MECHANICAL SHOP DRAWINGS

PROJECT: York Region Administrative
Centre – Interior Fit-up
Package 'D'

Shop Drawing No.: M-6

Product: Finned Tube Radiation

ZEHNDER RITTLING 100 RITTLING BLVD. • BUFFALO, NY USA 14220	
JOB:	
ENCLOSURE MODEL: SIBG5	
DATE: January 2011	DWG.NO.: SIBG5

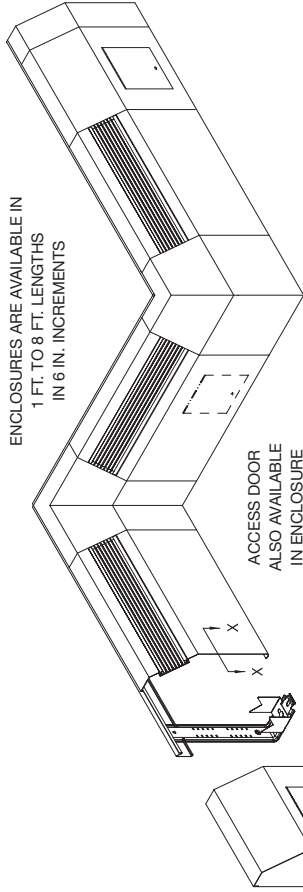
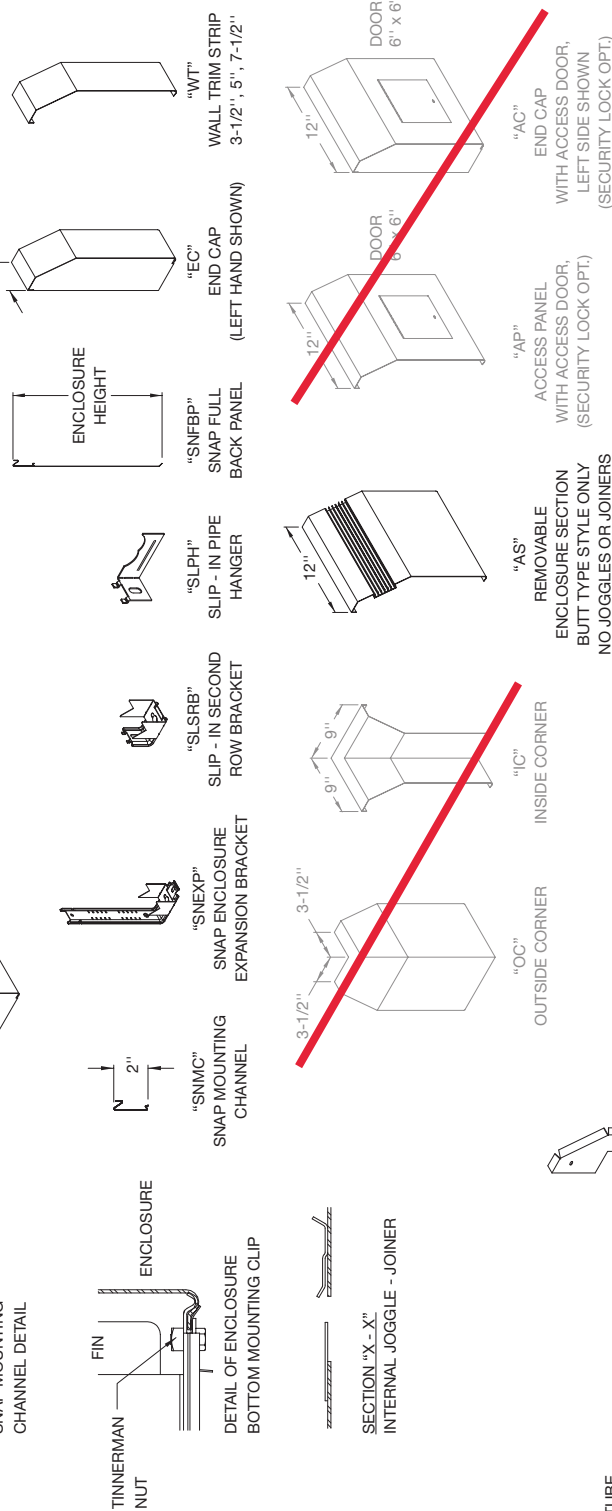
2. Wall fin radiators enclosure cabinet: **Acceptable, Ensure site measurements are provided to supplier for a continuous run along curved perimeter wall. Provide end caps on enclosure near wall where the enclosure meets the rain water leader/ altos partition. Enclosure shall be accessible at all times. Cabinet lengths along curved wall to be site measured to avoid gaps between cabinet and wall as per drawings. Contractor to ensure mounting channel and bracket are properly secured to the wall. Provide locking bottom mounting clip for enclosure.**

Standard Colors

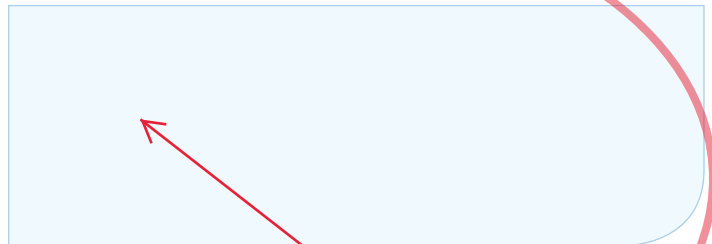
3. For valve locations, ensure 'AS' access enclosure shall come without grilles. Access panel shall be provided for control valve location.
4. Wall fin enclosure shall be color white.

Confirm White
